Network Outcomes Contract Clarification Governance Group Clarification

Reference Number:	NOCC No. 32
Subject Title:	Rehabilitation cut to waste and additional work activities
Issue Date:	09/09/2019
Clarification Purpose	Clarification is provided to ensure the NOC is being interpreted consistently. The clarification does not remove or supersede the Network Outcomes Contract documentation.

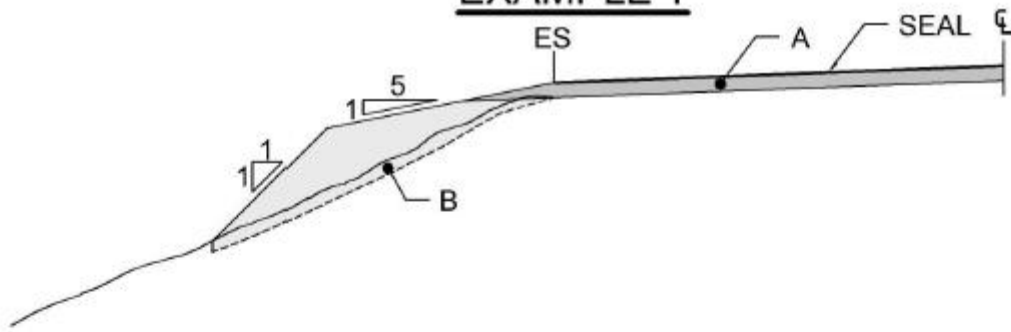
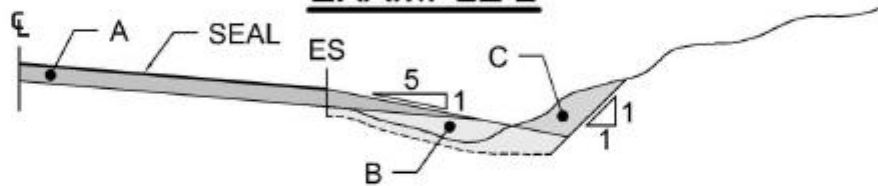
A NOC submitted a variation request relating to the construction of Rehabilitation sites in regards 'cut to waste' of material at tie-in joints at either end of the treatment length and 'cut to waste' of material in the shoulders.

For clarity, the tendered base rates shall also allow for the removal of all high lip, shoulder vegetation and all earthworks required to form a 1:5 shoulder slope that extends 2.0m beyond the new edge of seal (thus providing a surface water channel at least 0.4m deep); refer to the areas marked B and/or C on the typical cross-sections.

Area B represents the quantity of materials in excess of that allowed for in the Area A base rate as defined above. Area B therefore provides for additional material to address deep ruts, uneven surface shape, camber or super elevation, filling of dips in the longitudinal profile, additional seal width and /or shoulder fill where it is agreed these improvements

The intention is that Area C 'cut to fill', would be the preference to reutilise the material on site but if this was not feasible and if the material cannot be suitably used on site then some material would be cut to waste to a suitable, agreed nearby network infill location, and that both of these activities would be part of this tendered rate.

1. The intention is that the Examples Area C 'cut to fill' assumes this material/ quantity can be suitably used on site, then if so that activity would be part of the tendered rates being the SOP item 6.3.4.4.

2. Alternatively if that Area C noted as 'cut to fill' had to be 'cut to waste' then the SOP item 6.3.4.4 contract rate also expects the Contractor to have allowed for that material/quantity to be removed off site and reutilised as an infill material nearby on the network to obtain the best value for money outcome.

3. The Appendices section 6.2 Notes advise:
"It is recognised that the typical profiles indicated in examples 1 to 3 are not always achievable or cost effective due to site specific issues or constraints. Amendments will often be required in order to provide a more cost effective solution.
These issues shall be discussed and the outcomes agreed with the Principal prior to completing final design. Examples might include the use of steeper and /or narrower unsealed shoulder slopes in order to best fit the existing formation width, the use of gabion baskets to widen the formation, the use of subsoil drains to avoid extensive earthworks in cuttings and the likes. Such changes shall be reflected when determining the final quantity associated with Area B. Other agreed solutions shall be at scheduled contract rates, or by negotiation where none exist".
